PROPOSED CHANGE RTS-74 TO DAEC TECHNICAL SPECIFICATIONS

Revision 2 to Proposed Change RTS-124
to the
Duane Arnold Energy Center
Technical Specifications

The purpose of this change to the previous revision, RTS-124A submitted December 18, 1981, is to update the submittal for permanent licensing of Single Loop Operation (SLO) to be consistent with the Reload Licensing amendment for Cycle 7 (Amendment 88, issued April 25, 1983). The major changes deal with the increased Minimum Critical Power Ratio (MCPR) operating limits for 8 X 8 and P8 X 8R fuel and new Maximum Average Planar Linear Heat Generation Rate (MAPLHGR) curves for the fresh fuel for Cycle 7. Also this revision reflects the new NRC position which allows isolation of the out-of-service recirc. loop by electrically isolating the recirc. pump instead of closing the suction valve, as proposed in the previous submittal. This change allows the temperature in the idle loop to be maintained, reducing the thermal stress on the pipe. Several administrative changes are also included, dealing with updating references and deletion of blank pages. For clarity and conciseness, a list of the affected pages is included which supersedes t

Core Power Vs Recirc Loop Flow
 FIGURE 2.1-1

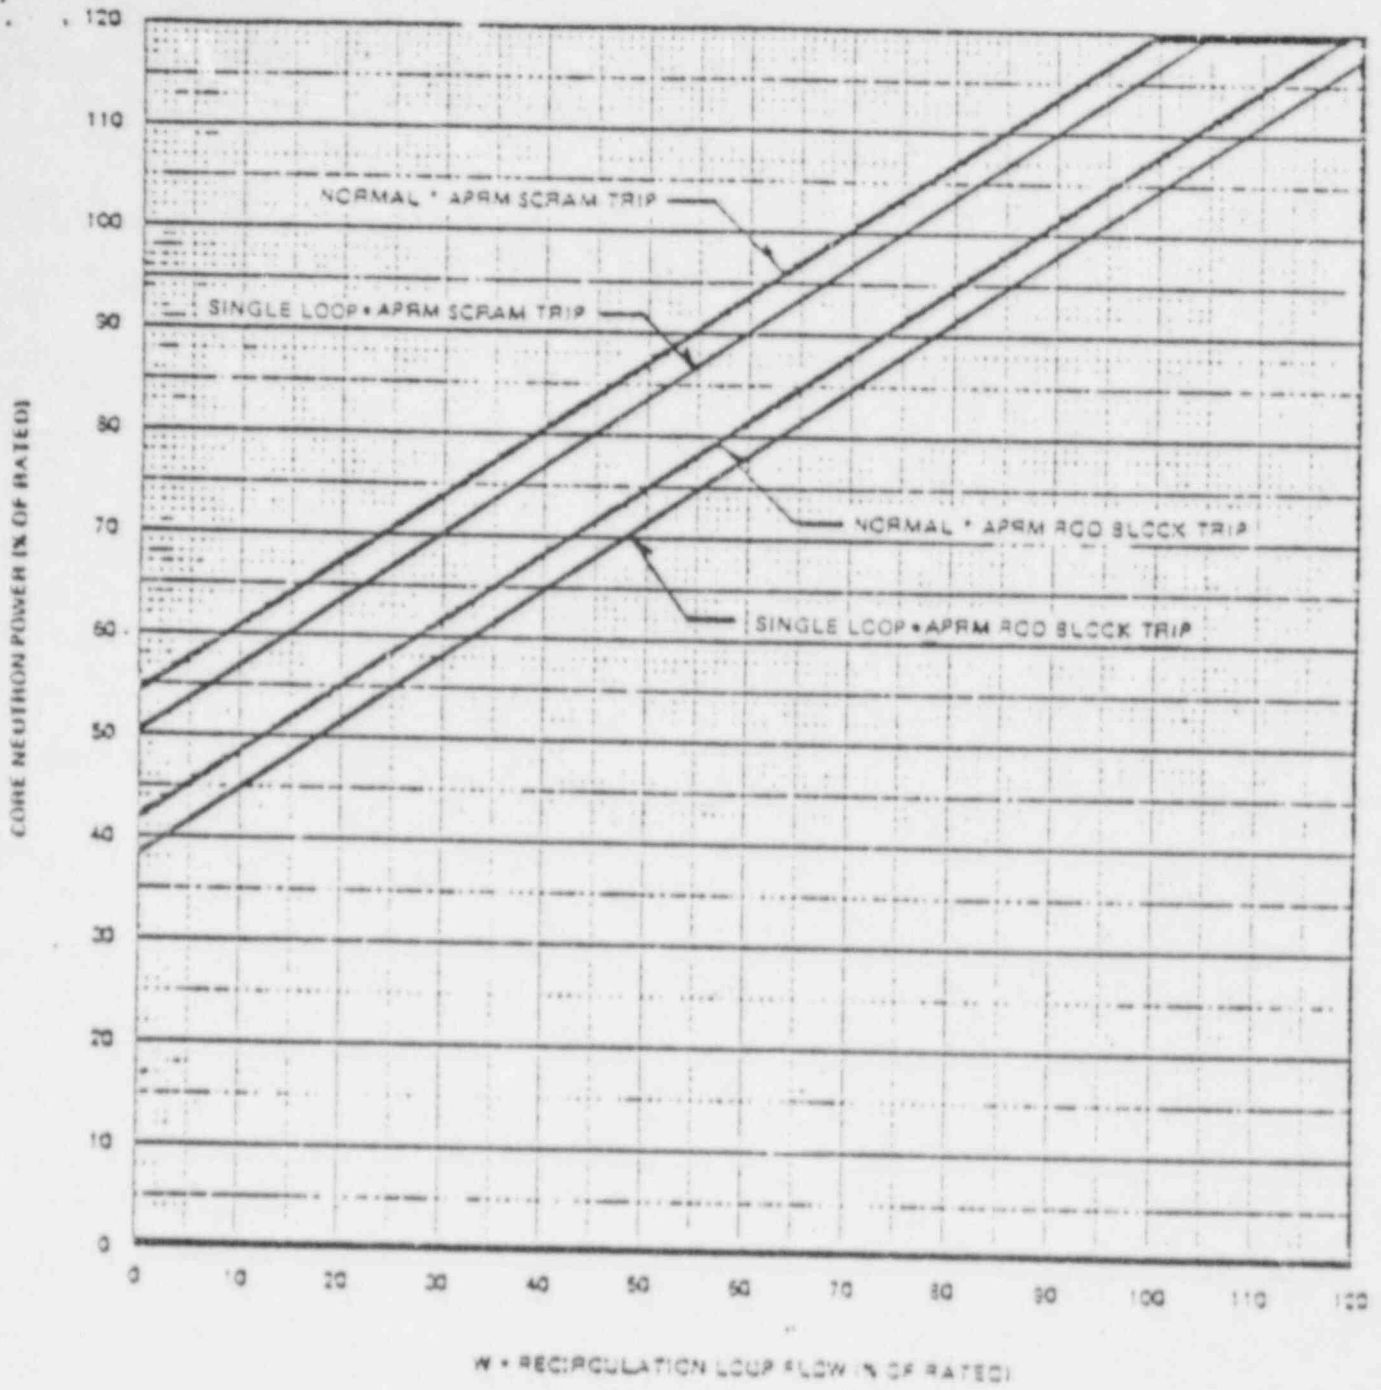
- 3) Add the APRM Flow-Biased Flux Scram and Rod Block Equations for SLO to Sections 2.1.A.1 and 2.1.A.3 respectively as well as Figure 2.1-1 and to Tables 3.1-1 and 3.2-C (pages 1.1-19, 3.1-3 and 3.2-16). Also add the SLO-modified Rod Block Monitor (RBM) equation to Table 3.2-C.

K_f AS A FUNCTION OF
 CORE FLOW
 FIGURE 3.12-1

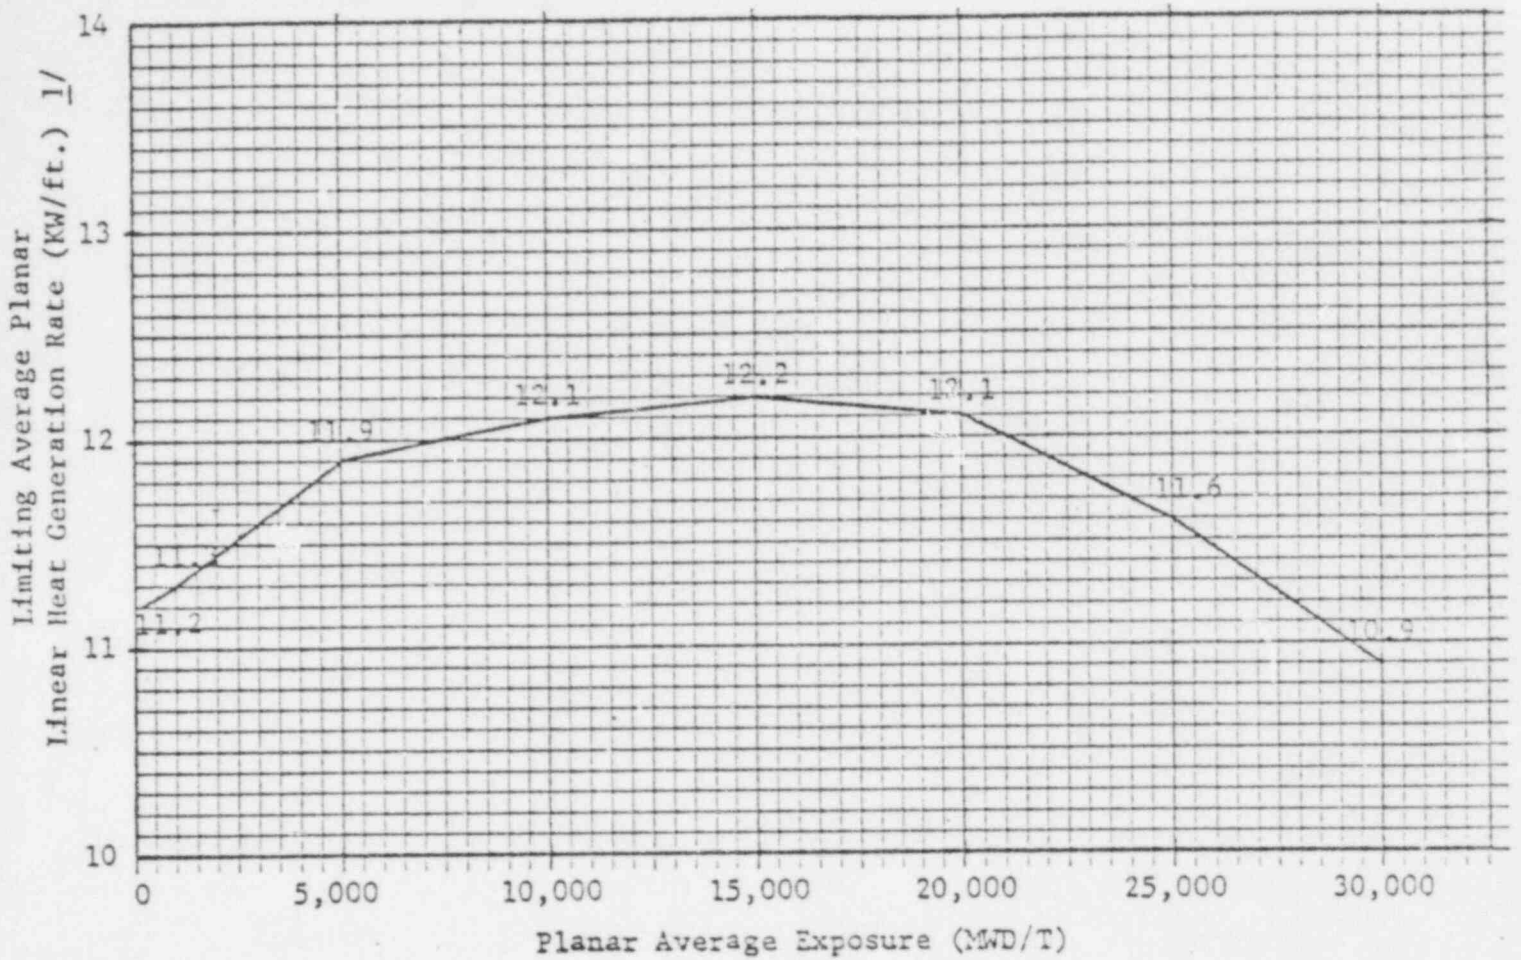
During reactor power operation MCPR for one or two recirculation loop operation shall be $>$ values as indicated in Table 3.12-2. These values are multiplied by K_f which is shown in figure 3.12-1. Note that for one recirculation loop operation the MCPR limits at rated flow are 0.03 higher than the comparable two-loop values. If at any time during reactor power operation (one or two loop) it is determined by normal surveillance that the limiting value for MCPR is being exceeded, action shall then be initiated within 15 minutes to restore operation to within the prescribed limits. If the operating MCPR is not returned to within the prescribed limits within two hours, reduce reactor power to $<$ 25% of rated thermal power, or to such a power level that the limits are again being met, within the next 4 hours.

DUANE ARNOLD ENERGY CENTER IOWA ELECTRIC LIGHT AND POWER COMPANY TECHNICAL SPECIFICATIONS
LIMITING AVERAGE PLANAR LINEAR HEAT GENERATION RATE AS A FUNCTION OF PLANAR AVERAGE EXPOSURE FUEL TYPE: 8D274L FIGURE 3.12-5

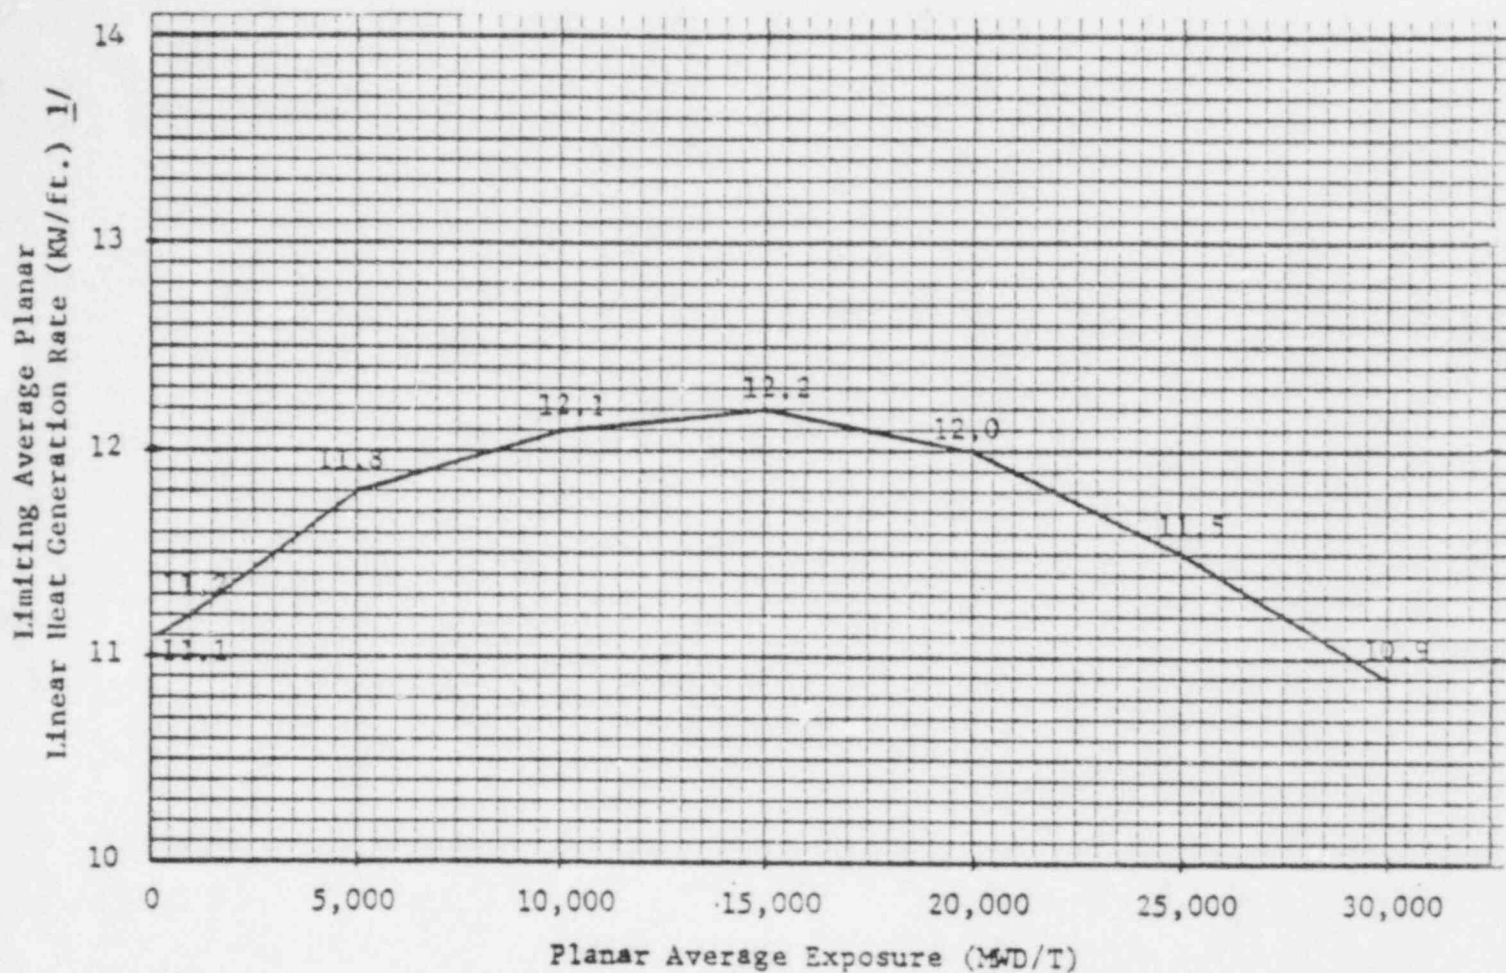
During reactor power operation, the actual MAPLHGR for each type of fuel as a function of average planar exposure shall not exceed the limiting value shown in Figs. 3.12-5, -6, -7, -8 and -9. For single-loop operation, the values in these curves are reduced by multiplying by 0.7. If at any time during reactor power operation (one or two loop) it is determined by normal surveillance that the limiting value for MAPLHGR (LAPLHGR) is being exceeded, action shall then be initiated within 15 minutes to restore operation to within the prescribed limits. If the MAPLHGR (LAPLHGR) is not returned to within the prescribed limits within 2 hours, reduce reactor power to $< 25\%$ of rated thermal power, or to such a power level that the limits are again being met, within the next 4 hours.
